S E R V I C E N O T E

4195A Network/Spectrum Analyzer**Serial Numbers:**

Modification to cure the problem of “No signal for spans less than 2.4 MHz”**Duplicate Service Notes:** None**To Be Performed By:** Agilent-Qualified Personnel**Parts Required:**

Figure 1. A18 Board Modification

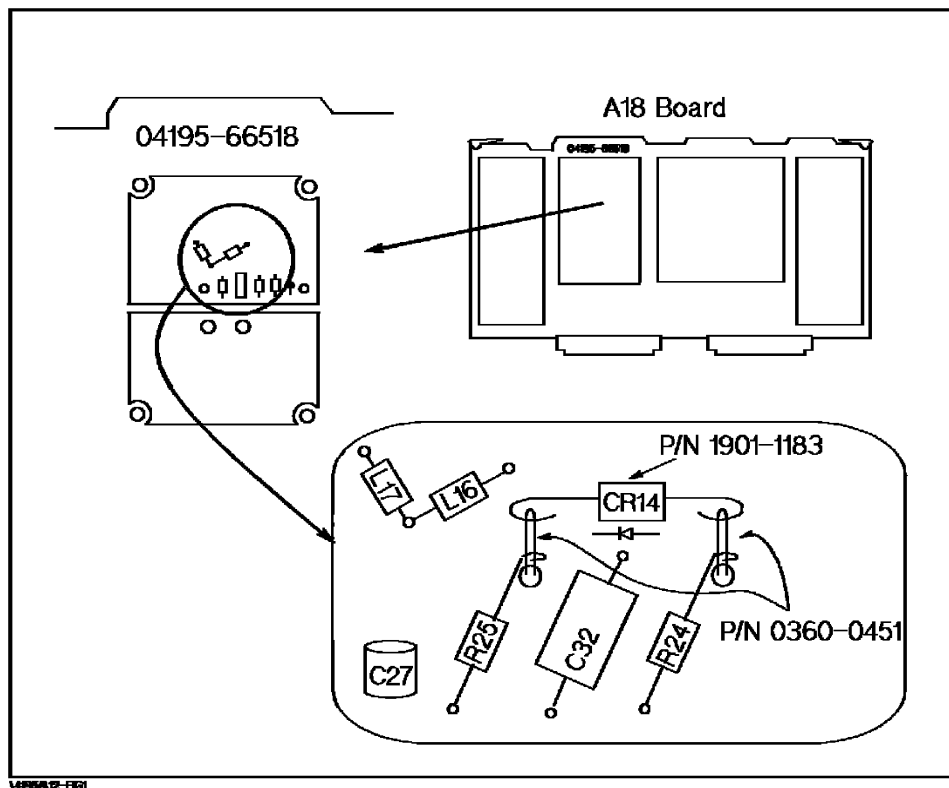
When the 4195A within the listed serial number range is turned on or when it sweeps the frequency with the frequency span less than 2.4 MHz, the phase locked loop may not work properly and the test signal may disappear.

Modify the A18 board using the following procedure:

1. Remove the top cover and the shield plate.
2. Remove the A18 board.
3. Remove one lead each of A18R24 and A18R25. See Figure 1.
4. Insert two TERM-SGL-PINS (P/N 0360-0451) from the component side into one-side-holes of A18R24 and A18R25. Solder the two pins.
5. Wrap the leads of A18R24 and A18R25 on the corresponding pins mounted in the holes for A18R24 and A18R25.
6. Wrap the leads of new DIODE (P/N 1901-1183, A18CR14) between the two pins. (Wrap the CATHODE lead of the DIODE to the pin of A18R25 and the ANODE lead to the pin of A18R24).
7. Solder the DIODE and A18R24/A18R25 mounted on the two pins.
8. Reinstall the A18 board.
9. Reinstall the shield plate and the top cover.
